The Commission has issued the enclosed Amendment No. 86 to Facility Operating License No. DPR-51 for Arkansas Nuclear One, Unit No. 1 (ANO-1). This amendment consists of changes to the Technical Specifications (TSs) in response to your application dated August 13, 1984.

Amendment No. 86
License No. DPR-51

ATTACHMENT TO LICENSE AMENDMENT NO. 86

SUPPORTING AMENDMENT NO. 86 TO FACILITY OPERATING LICENSE NO. DPR-51

FIGURE 4.18.1

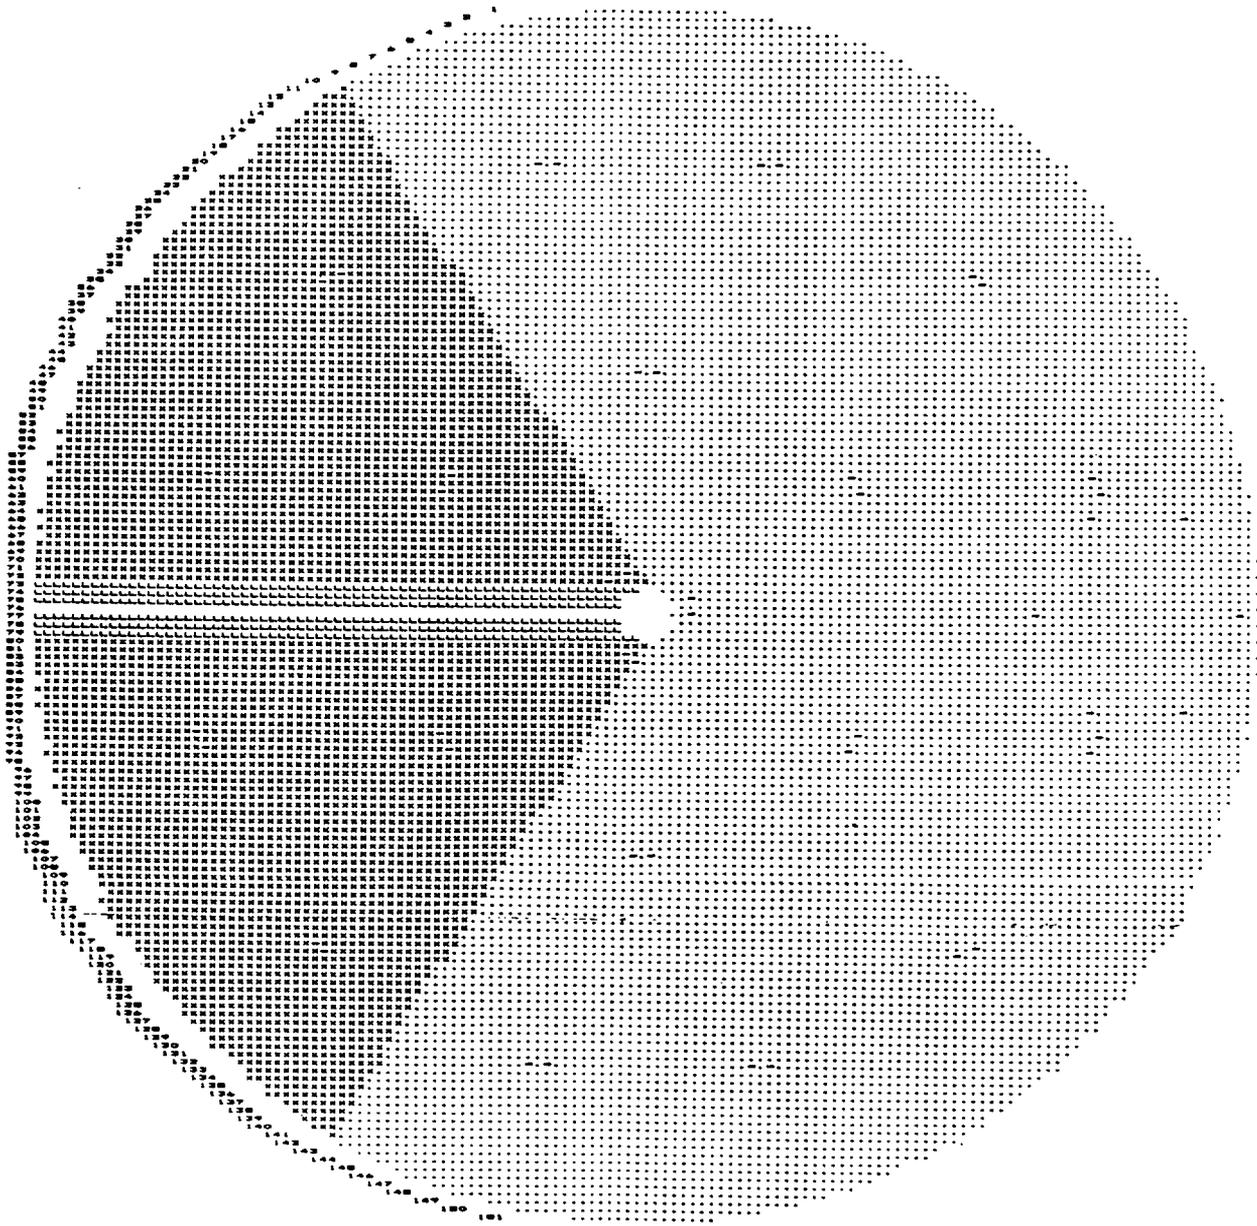
(3) Group A-3: Tubes in the wedge-shaped group on either side of the lane region (Group A-1) as defined by Figure 4.18.1.

In another change request, new special group A-3 is added. The new special group consists of 4,831 tubes adjacent to the lane region. The new group is a large wedge (1/3 of the tube bundle) originating at the center of the bundle fanning out on either side of the lane region. This new special group is selected due to tube degradation noted in recent steam generator tubing inservice inspections and recent leaker outage tube inspections. Sample analyses performed on tubes pulled during recent inspections have shown that IGA is the root cause of tube degradation leading to the plugging of approximately 280 tubes in the OTSGs. This attack has been concentrated in and around the lane region, group A-1, and at the periphery of the tube bundle near the lane. The proposed group A-3 more than adequately bounds the region of degraded tubing found to date.

fell well within the bounds of the large wedge. The heaviest concentration of degraded tubes were found within 10 rows of the lane and around the periphery either side of the lane. The majority of the IGA found to date has been located at and above the secondary face of the UTS. The inspection of the proposed new A-3 group from the 15th TSP up would provide adequate monitoring of the IGA problem.

3. Tubes in the following groups may be excluded from the first random sample if all tubes in a group in both steam generators are inspected. The inspection may be concentrated on those portions of the tubes where imperfections were previously found. No credit will be taken for these tubes in meeting minimum sample size requirements. Where only a portion of the tube is inspected, the remainder of the tube will be subjected to the random inspection.

(1) Group A-1: Tubes within one, two or three rows of the open inspection lane.

(2) Group A-2: deleted
